PLANNING COMMISSION AGENDA City Commission Chambers - City Hall 625 Center Street, Oregon City, Oregon 97045

July 23, 2012 at 7:00 p.m.

TO:	Oregon City Planning Commission	
FROM:	Laura Terway, Planner	
PRESENTER:	Laura Terway, Planner	
SUBJECT:	VR 12-01: Sign Variance	
Agenda Type: Public Hearing		
Approved by: Tony	Konkol, Community Development Director

FILE NO.:	VR 12-01: (Sign) Variance
FILE TYPE:	Quasi-Judicial
HEARING DATE:	July 23, 2012 7:00 p.m., City Hall 625 Center Street Oregon City, OR 97045
APPLICANT'S REPRESENATIVE:	Meyer Sign Company 5105 SW 74th Ave, Tigard, OR 97224
OWNER:	Investment Concepts, Inc., 1667 E. Lincoln Ave., Orange, CA 92865
REQUEST:	The applicant is requesting a variance to the Oregon City Sign Ordinance for a freestanding sign at the Oregon City Shopping Center.
LOCATION:	1900 SE McLoughlin Blvd, Oregon City, Oregon 97045 Clackamas County Map 2-2E-29, Tax Lot 1800 Oregon City Shopping Center
REVIEWER:	Laura Terway, AICP, Planner
RECOMMENDATION:	Staff recommends denial of VR 12-01
VICINITY MAP:	Exhibit 1

MANUFACTURE AND INSTALL ONE (1) D/F PYLON SIGN WITH TENANT PANELS

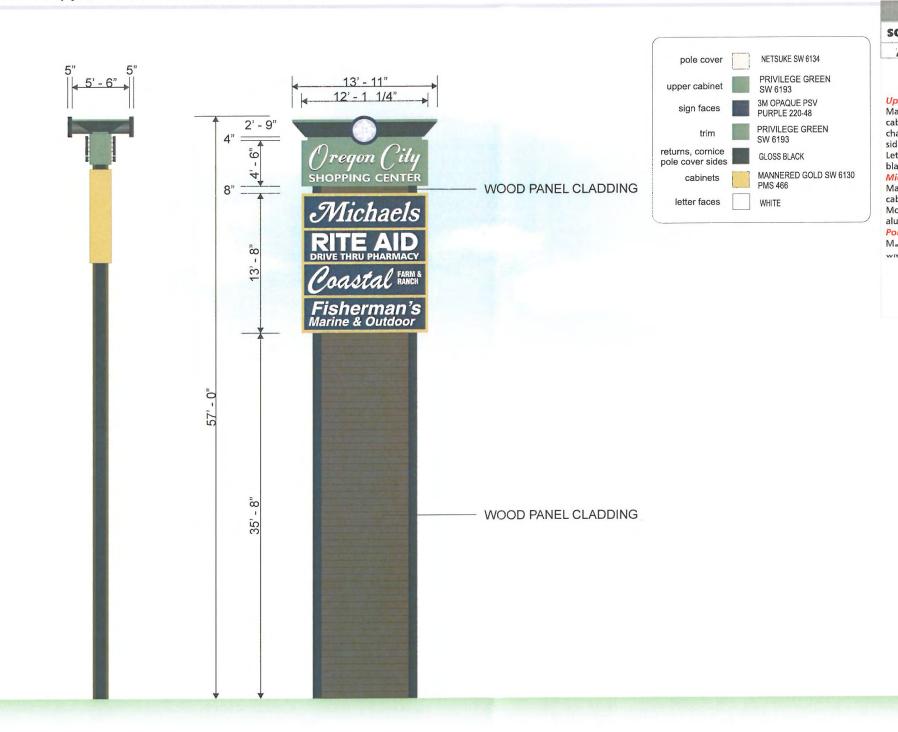
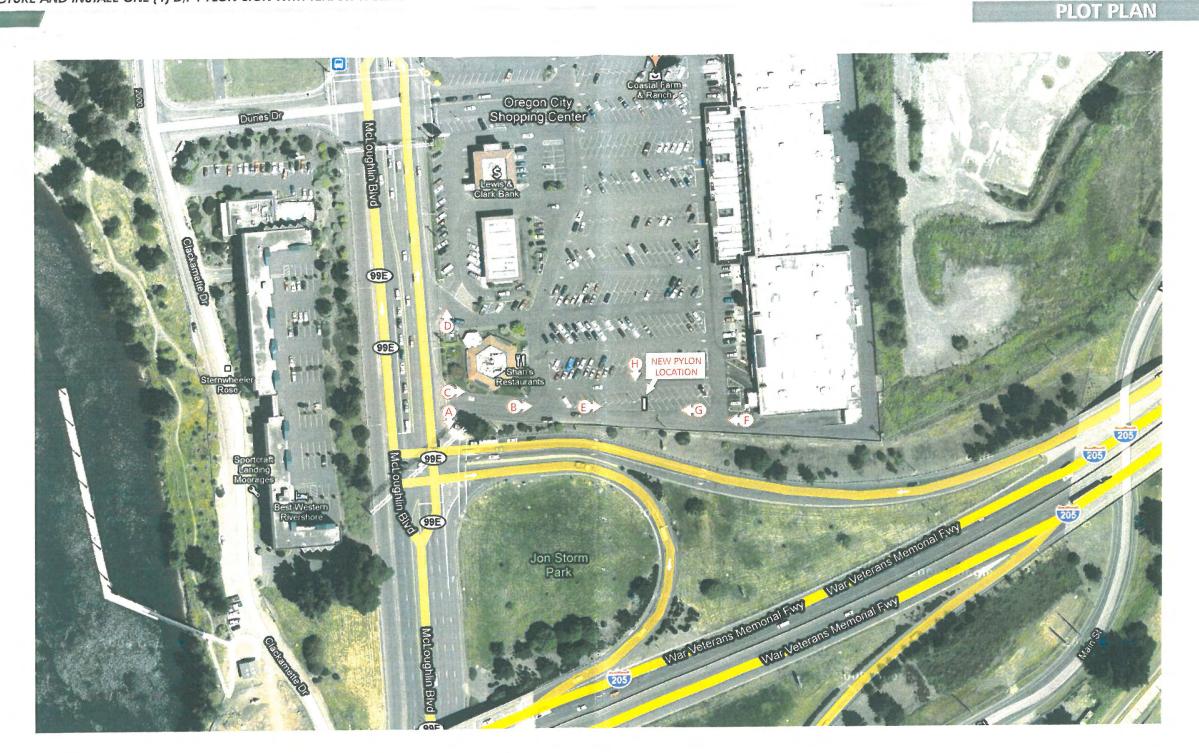
The Oregon City sign code does not provide a guarantee that signage is visible from adjacent freeways. Staff finds that the opportunity for adequate signage is provided by the sign code as the shopping center is allowed to install multiple large wall signs, two freestanding signs, a roof sign, projecting sign for each frontage (provided there is no free-standing or roof sign) and an incidental sign. The topography of the land adjacent to the subject site does not provide an exceptional and/or extraordinary circumstance because the site is still afforded a variety of opportunities for signage. **Staff finds that this standard has not been met.**

Staff recommends the Planning Commission deny Planning file VR 12-01.
